MODEL
2017-2018MY
Forte (YDm) 2.0L MPI

NUMBER
181 (Rev 1, 10/16/2019)

TECHNICAL SERVICE BULLETIN

SUBJECT: SERVICE ACTION: IGNITION COIL OR COIL RFI
SPRING REPLACEMENT FOR DTC P0300, P0301, P0302, P0303,
AND/OR P0304 (SA321)

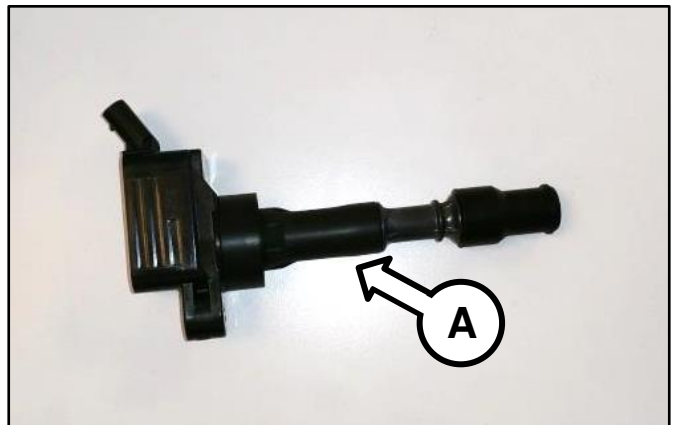
2. If a misfire (P030X) DTC is present, replace all four (4) ignition coils (A) with improved parts by referring to the "Engine Electrical System → Ignition System → Ignition Coil → Repair procedures" chapter in the applicable Shop Manual on KGIS then clear related DTC.

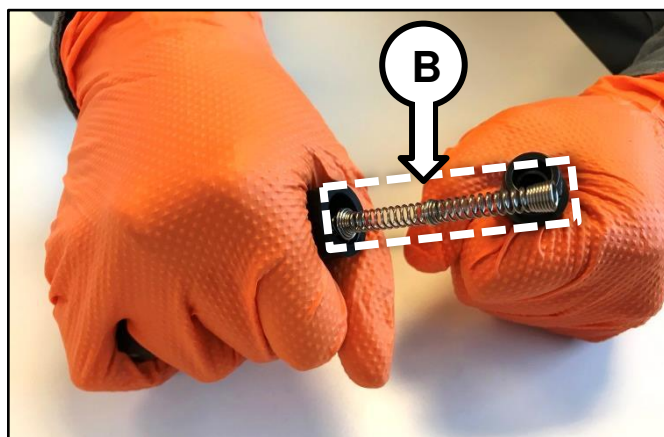
4. While firmly holding both ends, carefully wiggle and pull the ignition coil boot off from the igniter to expose the RFI spring (B).

5. Remove and replace the RFI spring with the new improved part.

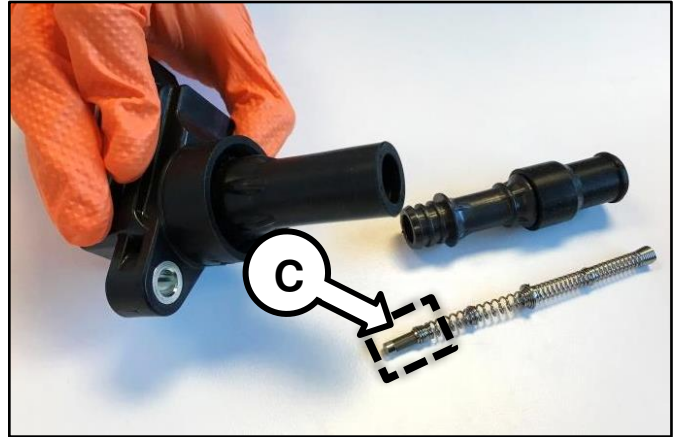
Ensure the RFI coated end (C) is inserted first into igniter part of the ignition coil assembly.
